REVISED RESPONSE TO REQUEST FOR ADDITIONAL INFORMATION

APR1400 Design Certification

Docket No. 52-046

RAI No.: 390-8479
SRP Section: 12.02 – Radiation Sources
Application Section: 12.02
Date of RAI Issue: 02/01/2016

Figure 1. Location of CR Emergency ACUs above the MCR

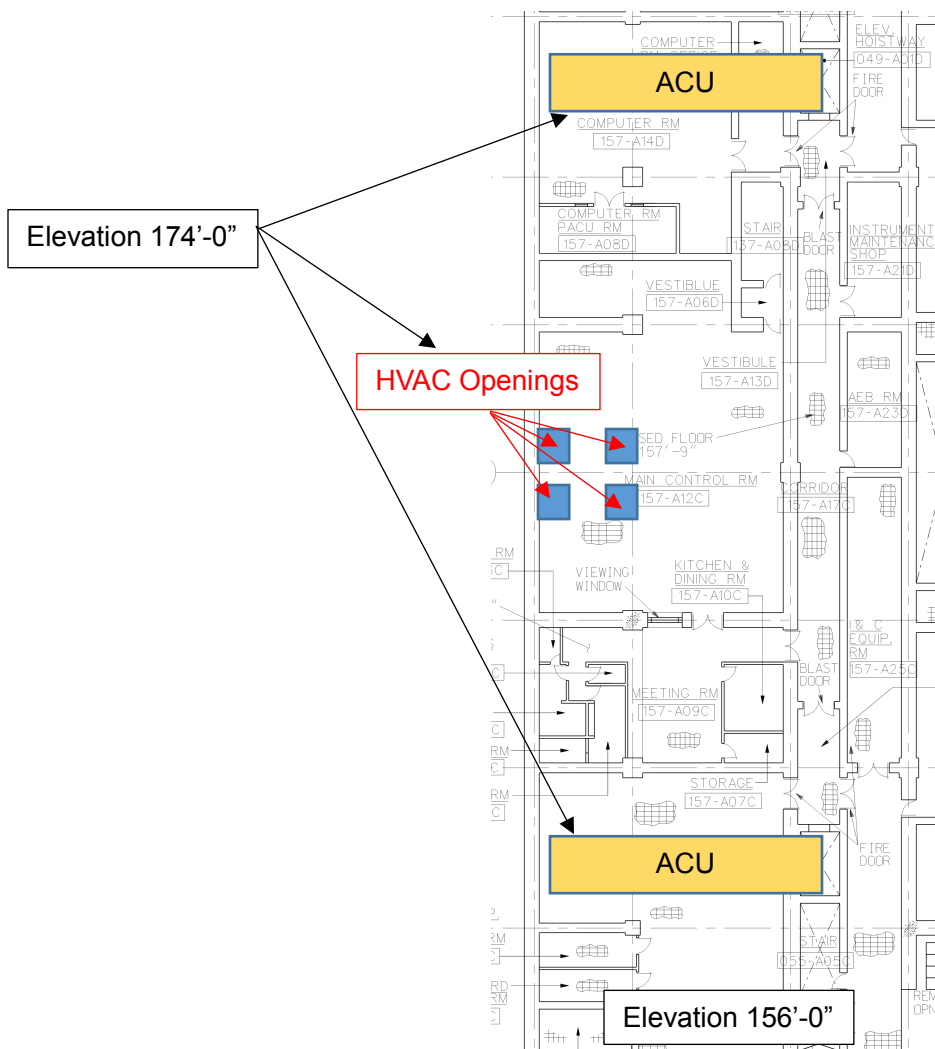
3. In the response, the applicant provides information indicating that containment penetrations will not be a significant dose contribution to CRE dose. Please specify if the design is such that it prevents a direct radiation streaming path or near direct radiation streaming path from the emergency filters (located above the main control room.) into the CRE through the ventilation ducting openings or other penetrations into the CRE.

- The two control room emergency air cleaning units, at elevation 174'-0", are not located directly above the main control room (MCR) at elevation 156'-0"; one is located above the computer room (plant north side of the MCR), and the other above the TSC room on the south side of the MCR. Their locations are indicated in the attached sketch (Figure 1) for illustration purposes. Based on these locations, the air supply and exhaust duct penetrations are designed to be located away from the CR Emergency ACU to prevent direct, or near direct, radiation streaming pathways. [The description on why the streaming from the ACUs is not considered will be added in Table 6.4-1.](#)

The two control room emergency air cleaning units (ACUs) are located above the computer room (plant north side of the MCR) and the TSC room on the south side of the MCR, respectively. Therefore, since the air supply and exhaust duct penetrations located above MCR are designed to be located away from the emergency ACUs, the direct, or near direct, radiation streaming through these penetrations is not a concern.
